TSG-RAN Meeting #6
Nice, France, 13 – 15 December 1999

TSGRP#6(99)689

Title: **Agreed CRs of category "B" (New features) to TS 25.215**

Source: **TSG-RAN WG1**

Figure 1 Measuring the "Observed time difference to GSM cell

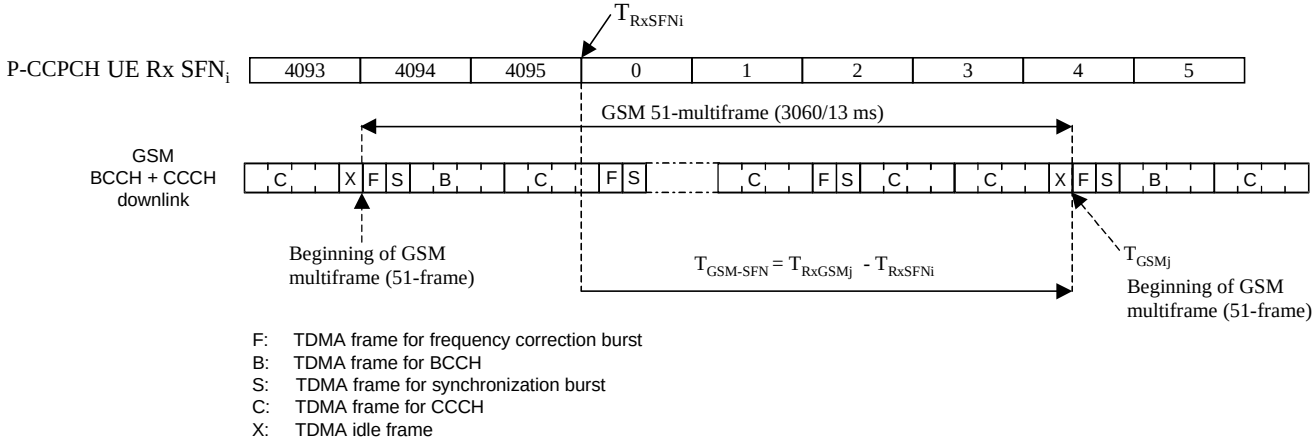
The aim of this CR is to incorporate the measurement "Observed time difference to GSM cell" for the UE in the layer 1 specification 25.215.

This measurement shall be supported by multimode FDD/GSM and FDD/TDD/GSM terminals. The measurement of "Observed time difference to GSM cell" is defined by WG2 in TS 25.302 as: Time difference between the Primary CCPCH of the current cell and the timing of the GSM cell.

The measurement of "Observed time difference to GSM cell" is shown in figure 1, where:

$\mathbf{T_{GSM\text{-}SFN}} = T_{RxGSMj} - T_{RxSFNi}$

$\mathbf{T_{RxSFNi}}$ is the time at the beginning of the P-CCPCH frame with SFN=0 from cell i.

$\mathbf{T_{RxGSMj}}$ is the time at the beginning the GSM BCCH 51-multiframe from GSM frequency j received closest in time after the time T_{RxSFNi}.

The UE can be requested to perform this measurement at any SFN and it is not necessary for the UE to wait until SFN=0 to perform the measurement. As the frame structures between UMTS and GSM is sliding in time it is however important to define if it is the previous or the next occurrence of SFN=0 that the measurement shall refer to if the UE measures the timing at any other SFN. It is proposed that the timing measurement shall reflect the timing situation when the most recent (in time) P-CCPCH with SFN=0 was received in the UE.

5.1.15 Observed time difference to GSM cell

Definition	The Observed time difference to GSM cell is defined as: $T_{RxGSMj} - T_{RxSFNi}$, where: T_{RxSFNi} is the time at the beginning of the P-CCPCH frame with SFN=0 from cell i. T_{RxGSMj} is the time at the beginning of the GSM BCCH 51-multiframe from GSM frequency j received closest in time after the time T_{RxSFNi}. If the next GSM multiframe is received exactly at T_{RxSFNi} then $T_{RxGSMj} = T_{RxSFNi}$ (which leads to $T_{RxGSMj} - T_{RxSFNi} = 0$). The timing measurement shall reflect the timing situation when the most recent (in time) P-CCPCH with SFN=0 was received in the UE.
Applicable for	Idle, Connected Inter
Range/mapping
